ADDENDUM NO. 2 TO PROJECT NO. Q1954

CONSTRUCTION, HVAC, PLUMBING AND ELECTRICAL WORK PROVIDE STORAGE STRUCTURE, BUILDING 38 BRONX PSYCHIATRIC CENTER 1500 WATERS PLACE BRONX, NY

September 5, 2025

SIDEWALL FRAMING: FRAME LINE A

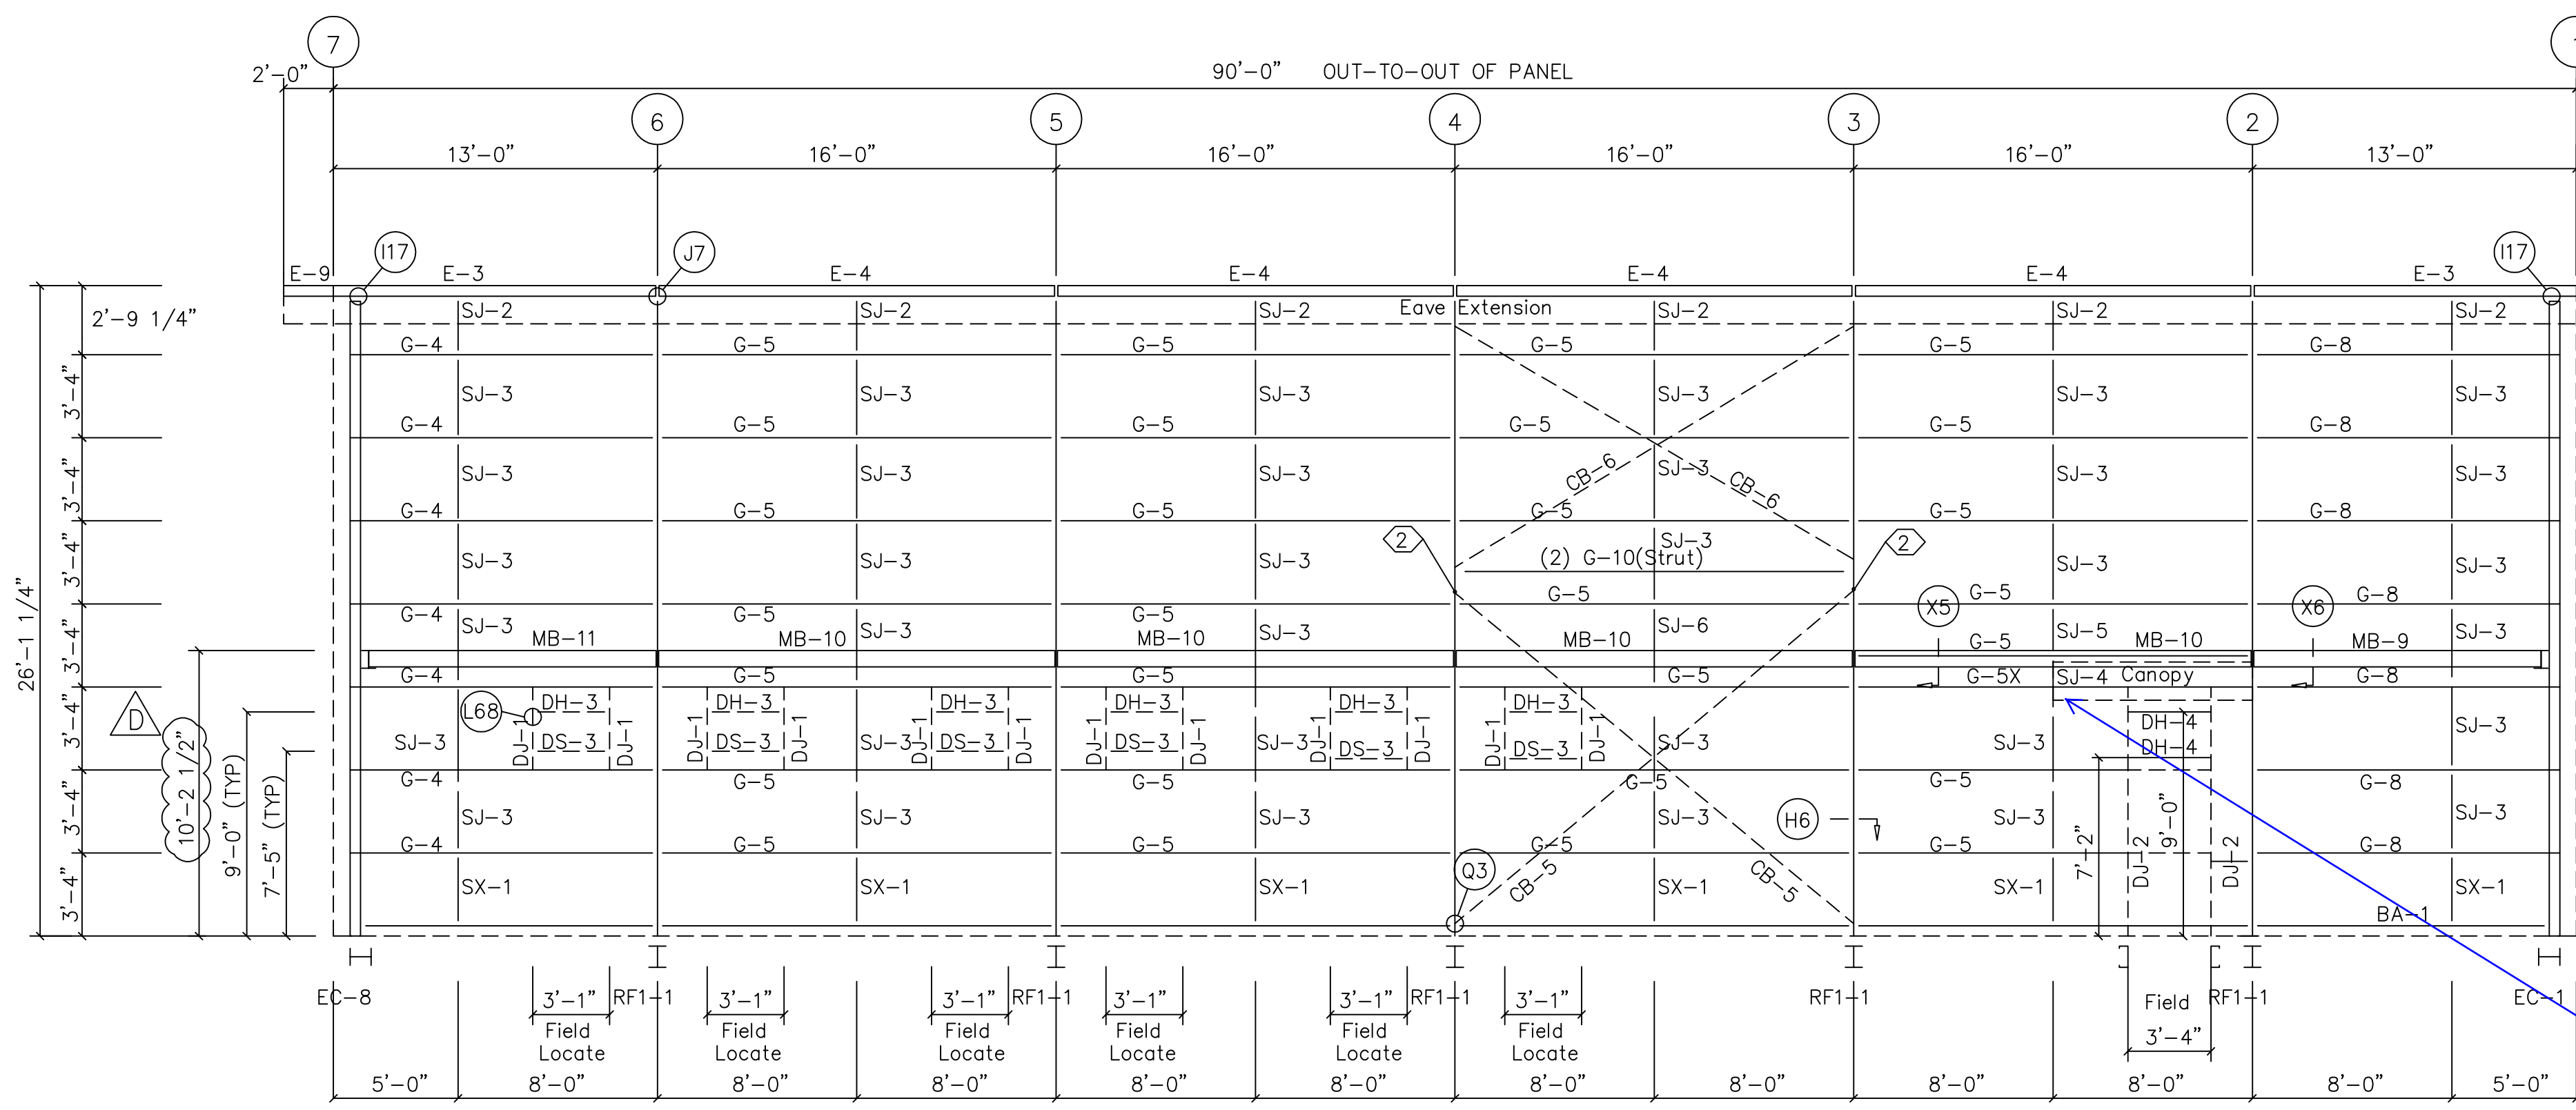
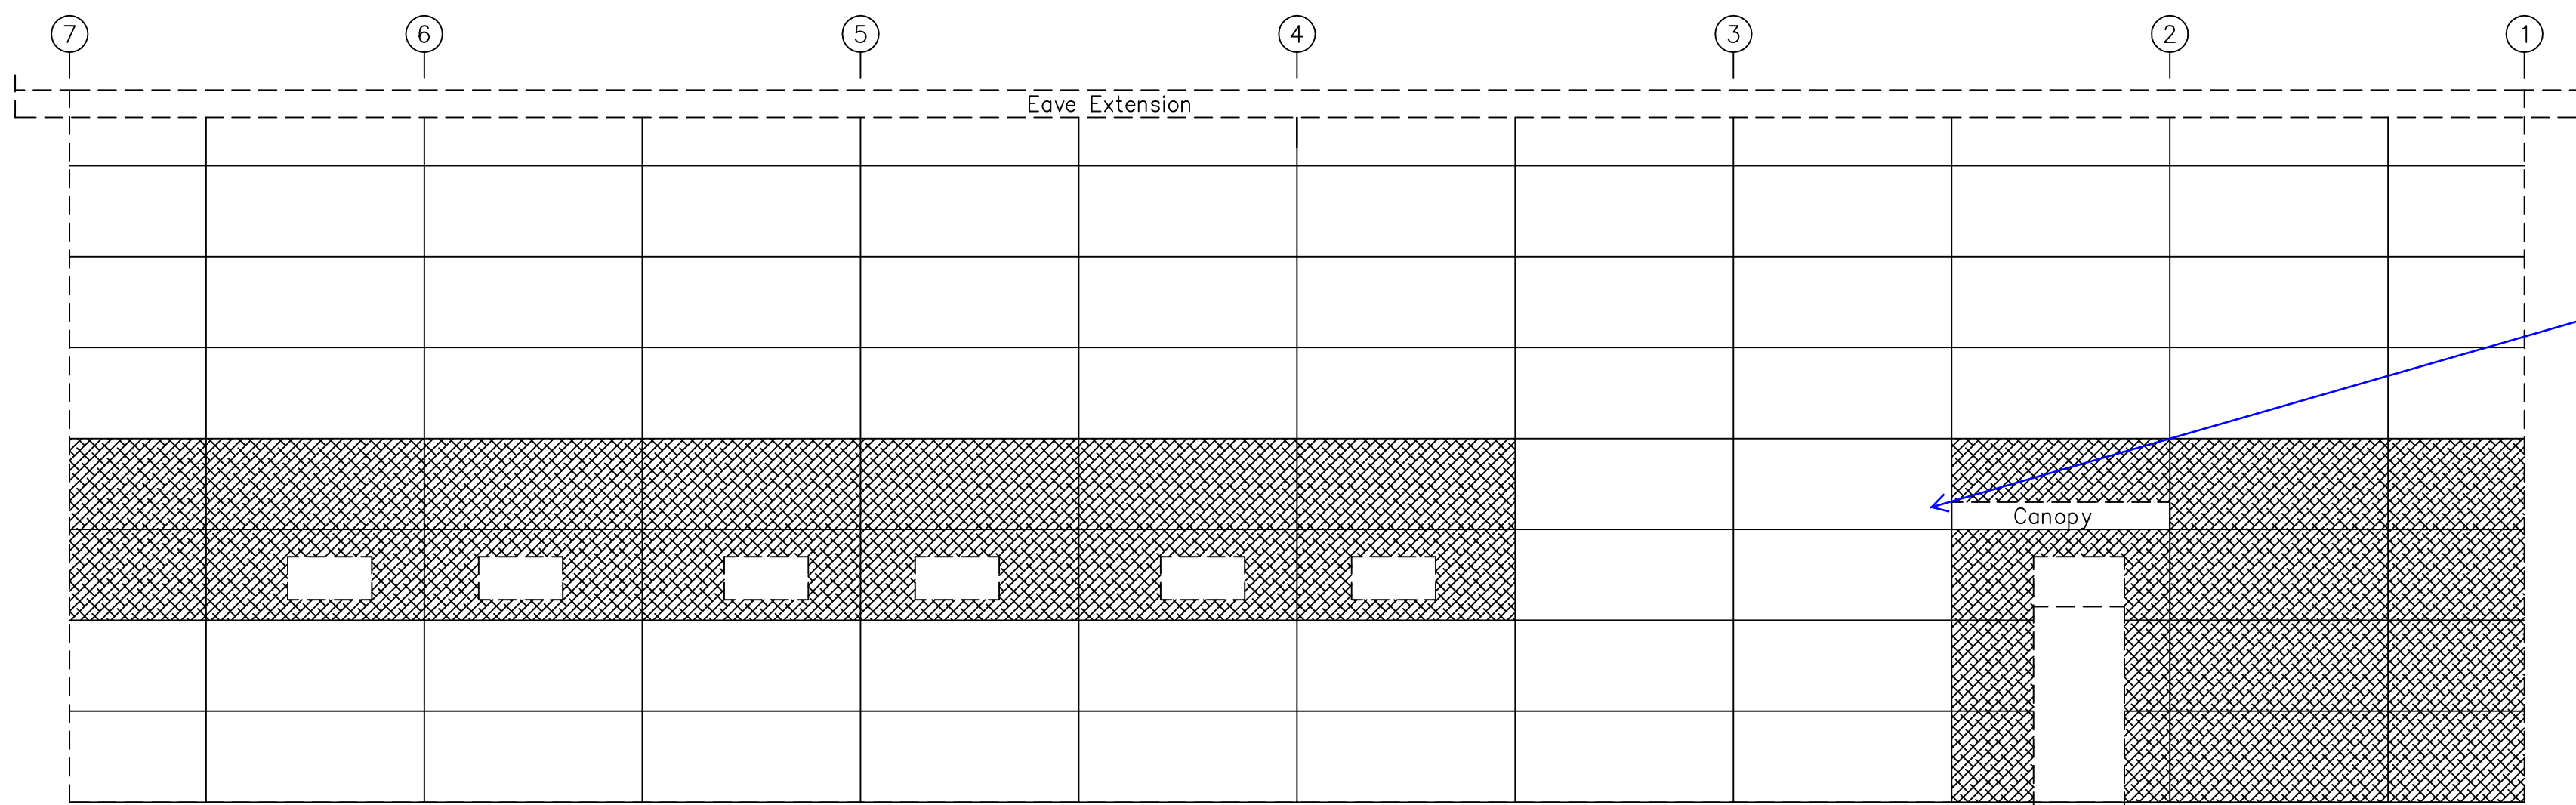
Detail shows a steel outrigger bolted to frame column to support the canopy. For the condition at Grid 2 that works but what is proposed to support the outrigger at this end of the canopy?
